**SOUTH CAROLINA ELECTRIC & GAS COMPANY
SALUDA HYDRO PROJECT RELICENSING
DOWNSTREAM FLOWS TECHNICAL WORKING COMMITTEE**

**SCDNR HEADQUARTERS
September 20, 2006**

**DOWNSTREAM RECREATION FLOW ASSESSMENT
STUDY PLAN**

Response to Comments Submitted to Draft Downstream Recreation Flow Assessment Study Plan

Figure 2: Study Area for Downstream Flow Assessment and Approximate Locations for Level Loggers
 (Source: South Carolina Department of Natural Resources, as modified by Kleinschmidt)

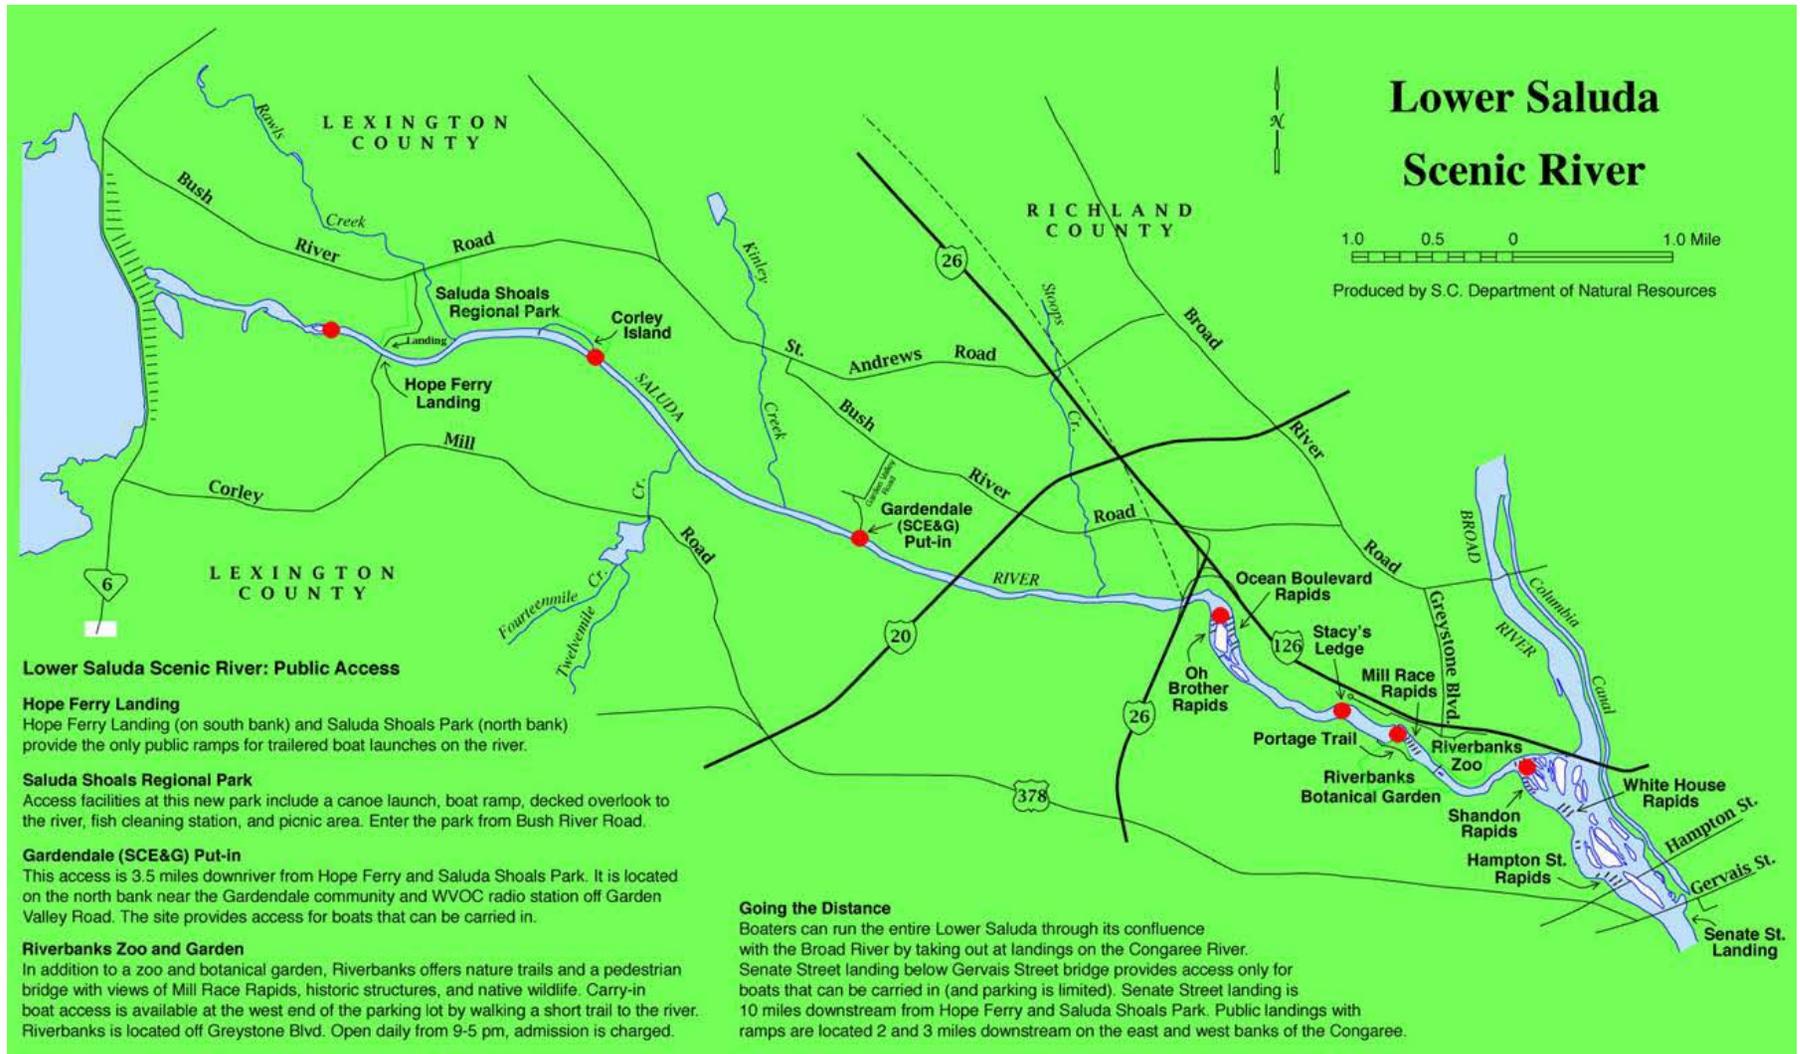
The group continued to review the study plan and Dave briefly discussed the goals of the study plan. There were no comments provided on Goals One and Two. Dave read Goal Three and it was noted that “public” should be inserted before the word “ingress” for Objective Three of Goal Three. Dave then briefly reviewed the locations the level loggers will be placed in the lower Saluda River. He noted that rate of change will be estimated between each location. There was some discussion about where the level loggers will be placed in the LSR and the group agreed that a second level logger should be added to Oh Brother Rapids and Ocean Boulevard locations.

Tony Bebber	<p>Red dots are insufficient areas to consider. These appear to be major kayaking areas. You must consider other recreational activities – wade fishing, bank fishing, swimming, tubing, rock use, sunbathing, picnicking, walking, bicycling, etc.</p>	<p>Red dots correlate with the HEC Res-Sim model cross sections that will be used for assessment of recreational flows and provide a range of hydrological conditions (pools, riffle, shoals). Red dots also correlate with or are within proximity of recreation access sites. Recreational activities are likely concentrated in areas in proximity of these access sites (for example, rock use, sunbathing, etc. occurs frequently at Mill Race, which is also considered a kayaking area).</p>
